## LAKE NONA SOUTHERN CIRCULATION PLAN

### SUMMARY

Southern Circulation Specific Parcel  
Master Plan Amendment

Exhibit 2.12  
Laureate Park Phases 3A & 3B  
Major Roadway Network

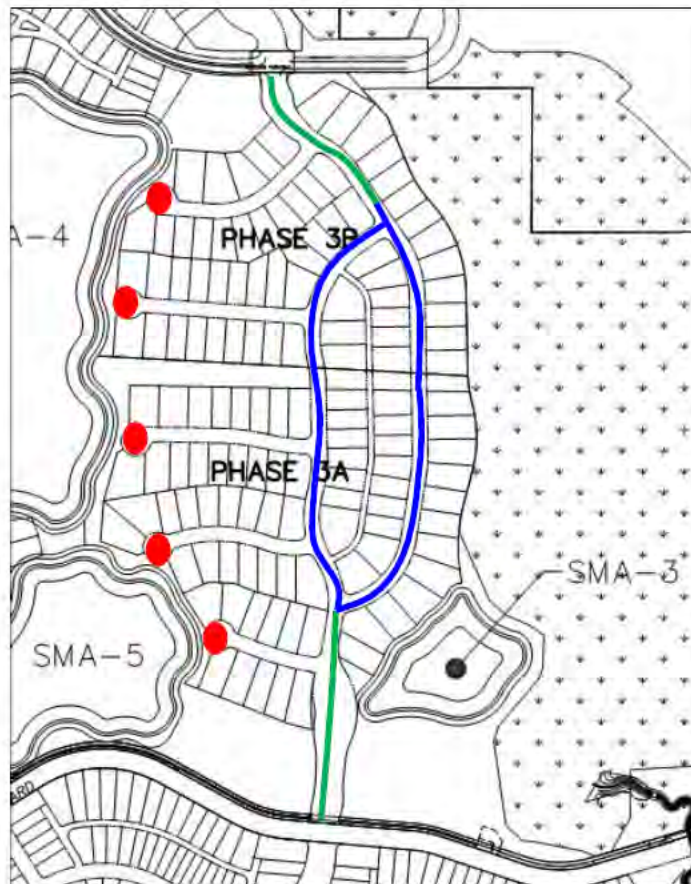
The following pages depict road segments and cross sections that have been previously approved by the SETDRC. On page 7 of this report, it depicts a cross section that was not included in the Laureate Park Phase 3 SPMP (Case #MPL2011-00015). It shows a cul-de-sac with a 100 foot right of way with 5 foot sidewalks on both sides, 4.5 foot landscape strip and 6 inch vertical curb on both sides, two 20 foot drive aisles and one foot ribbon curbs, and 38 a foot median. Five cul-de sacs were shown on the site plan of the Laureate Park Phase 3 SPMP, however, the cross section for this road type was not. This amendment to the Lake Nona Southern Circulation Plan includes this cross section for approval.

### Exhibit 2.21 Mixed Use District Block Structure

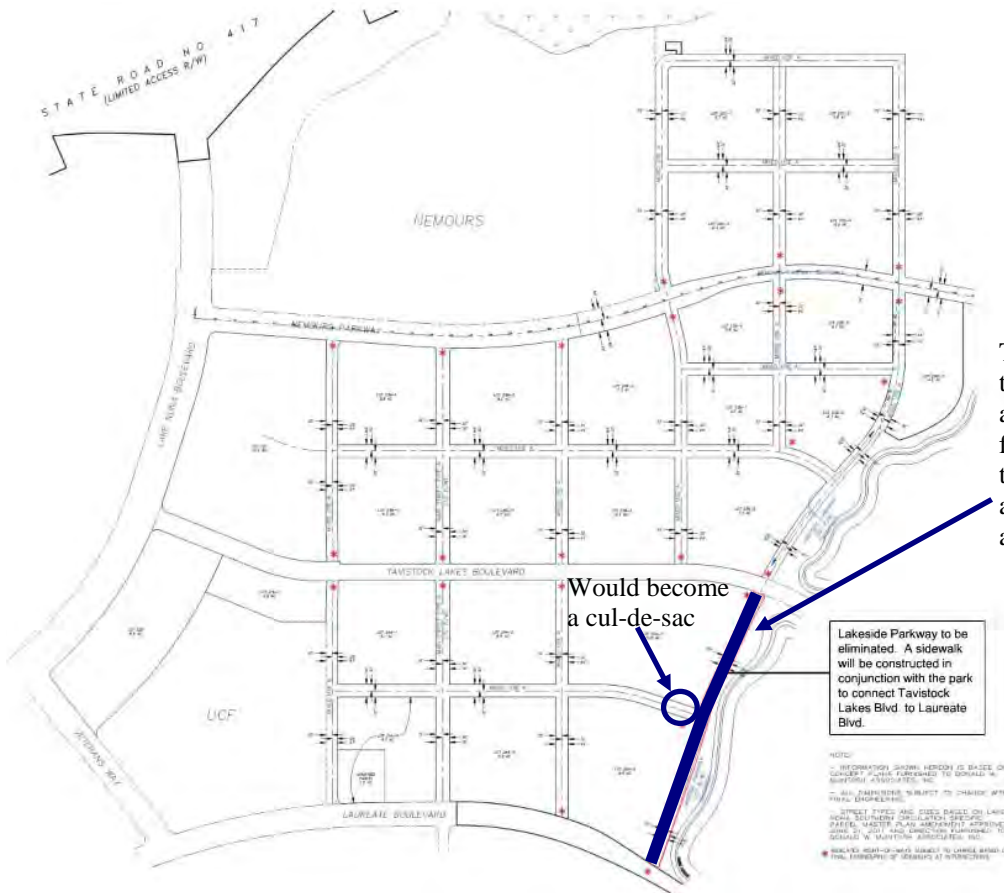
On page 9 of this report, the applicant is requesting to eliminate the Lakeside Parkway between Tavistock Lakes Boulevard and Laureate Boulevard. This Lakeside Parkway segment was approved with the Lake Nona Mixed Use District SPMP (Case #MPL2013-00040). During staff review, many departments have concerns regarding the elimination of this roadway. According to GMP Future Land Use Policy 4.1.15, *“Parks shall be surrounded by streets and/or building fronts, except where they are bound by woodlands, creeks, agricultural uses or other significant open space features. At least 50% of a park’s perimeter should front onto a public street...”*

The applicant is requesting to eliminate this Lakeside Parkway road segment and just build a sidewalk in this location for a park area. Staff has concerns that this removal will affect the grid system and create blocks larger than what is allowed by the LDC.

According to GMP Future Land Use Policy 4.1.15, "*Parks shall be surrounded by streets and/or building fronts, except where they are bound by woodlands, creeks, agricultural uses or other significant open space features. At least 50% of a park's perimeter should front onto a public street...*" The applicant has indicated that the vision for the Mixed Use District has evolved, and if this road is eliminated, the applicant would be required to submit a PD amendment to the Lake Nona PD to make changes to the Mixed Use District standards, prior to approval of any other phases in the Mixed Use District.

The park that will replace the deleted north-south street along the west side of the lake shall include a 12 ft wide (minimum) multi-use trail. The trail should mimic the shape of the shoreline where possible. Parking for the park and visitors to the area shall be created at the eastern terminus of the east-west street running along the north boundary of the Gathering. This parking area shall include space to allow vehicles to exit the parking area without backing onto the street. Bicycle parking racks shall be provided at appropriate locations along the park. Racks shall meet City standards, be located on impervious surfaces, and located to avoid conflicts with pedestrians or other vehicles.

1. Roadway network connectivity will be reduced; redundancy in the grid network and loss of on-street parking will also be reduced due to the proposed layout.
2. Close to 300 parking spaces would be lost with the adjustment from two lanes to one of the east/west roads and the elimination of the north/south road.

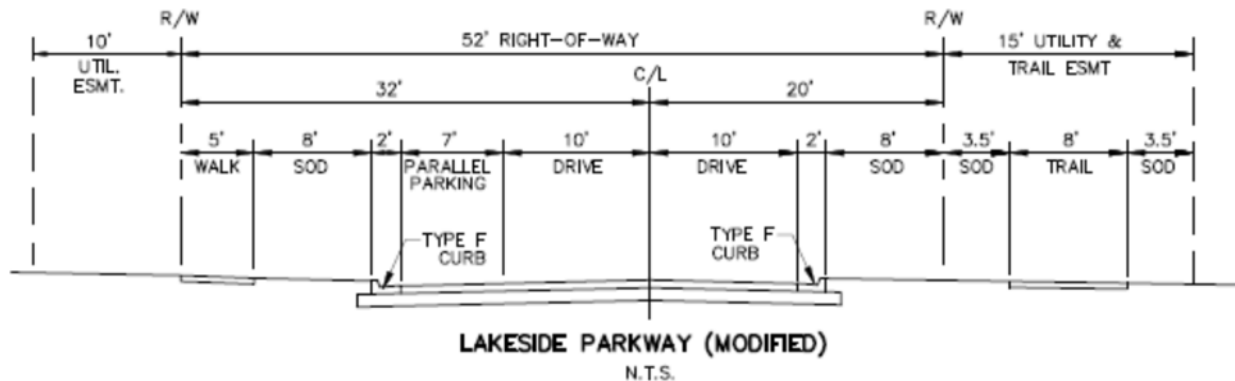
This cross section for the Lakeside Parkway was approved with the Lake Nona Mixed Use District SPMP (Case #MPL2013-00040). The applicant is requesting to eliminate the segment of roadway between Tavistock Lakes Boulevard and Laureate Boulevard. This cross section depicts one side of parallel parking for this area that if removed, it will affect some parking in this area. Also, the adjacent east-west street would become a cul-de-sac.
